CERTIFICATE OF APPROPRIATENESS

Property: Tracks 17 & 18, Block 16. The property includes an historic square foot, single-story stucco single-family residence and detached garage situated on a 6,000 square foot (50' x 120') interior lot.

Proposal: Accessory dwelling in rear 494 sq. ft.

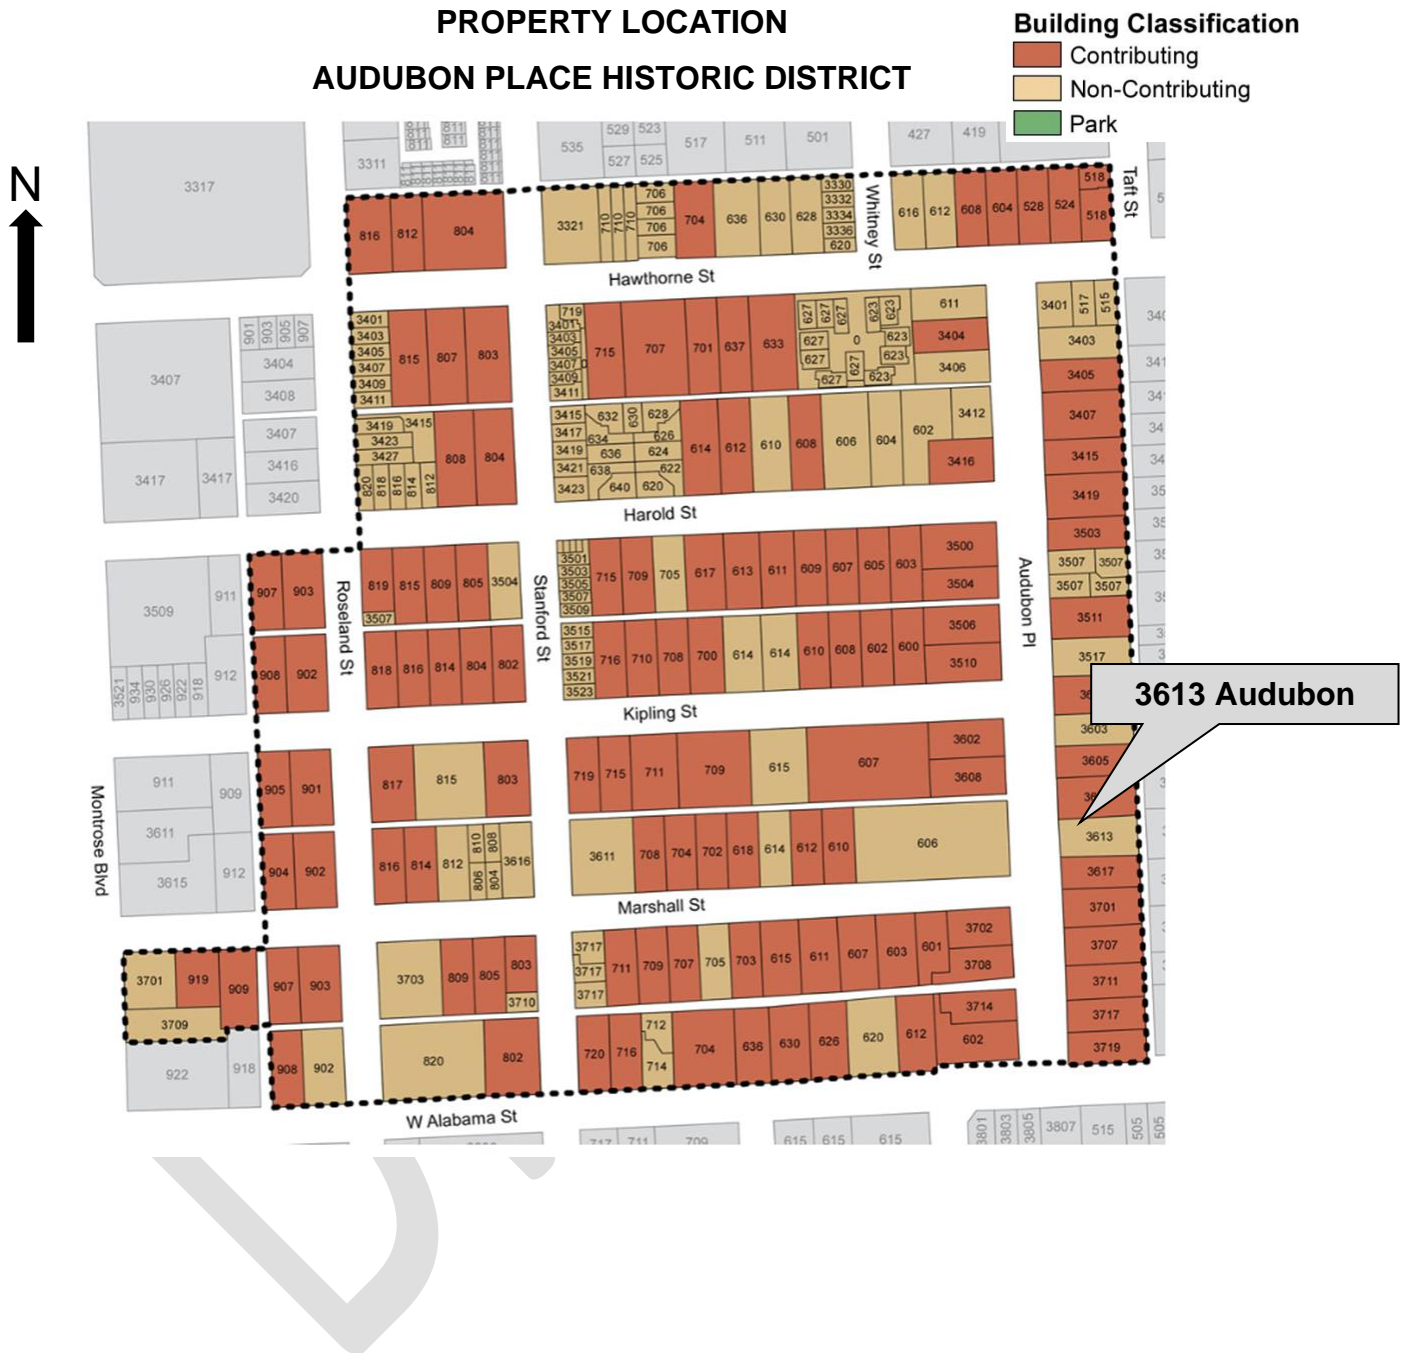
(a) The proposed activity must recognize the building, structure, object or site as a product of its own time and avoid alterations that seek to create an earlier or later appearance; and Replacement window is a simulated divided light window, is not representative of original window.

Recommendation: -Denial and Issuance of COR for work as completed with the following conditions: 1. installation of 1" x 4" vertical boards set at approximately 1' intervals to simulate the previous board and batten siding. 2. trim two (2) front facing (West elevation) windows, right side (South elevation) windows and front door to match the context area, to be approved by staff, and 3. Install exterior mullions (simulated window grille) over the front facing window on the 2nd floor.
